ARCHITECTURAL COMMITTEE
APPLICATION FOR EXTERIOR IMPROVEMENTS/CHANGES

NEIGHBORHOOD: Virginia Water

LOT #: 113

SUBMITTAL SUBJECT: Generator installation, right side of home screened by existing shrubs per pictures

BOUNDARY SURVEY OF: LOT 113, VIRGINIA WATER

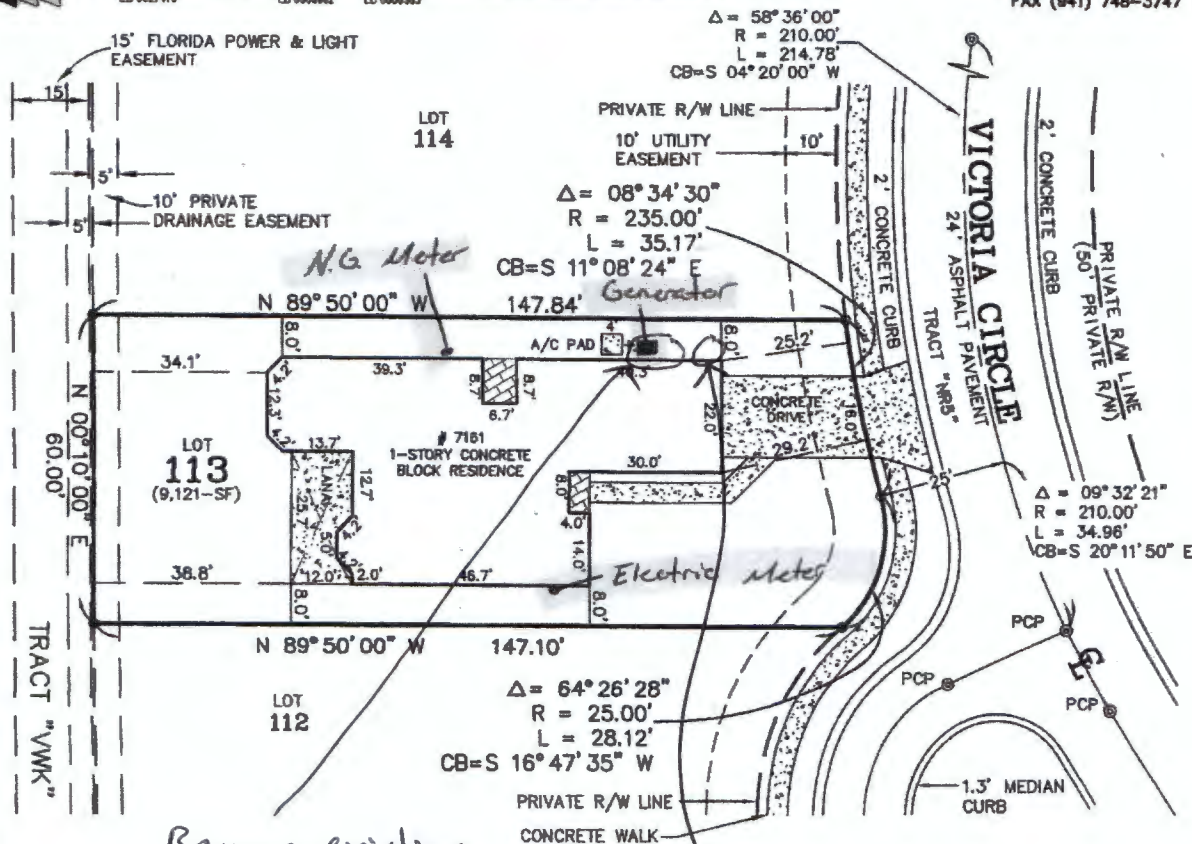
Install 22kw Generator with (1) 200 Amp Load Shedding Transfer Switch
On a PRE-POURED Concrete Pad
Connected to Existing Natural Gas
5' from any window, door, or opening, 4.4' from property line
Generator will NOT encroach easement
Generator will be 10' + from any neighbors equipment

Remove existing shrubs to create space for generator installation

Leave 3-4 shrubs to act as screen

Meets all ALC Criteria. Generator to be screened with 10-gallon hedge form style landscape material (planted on 24" centers) that have the capacity to screen the equipment.
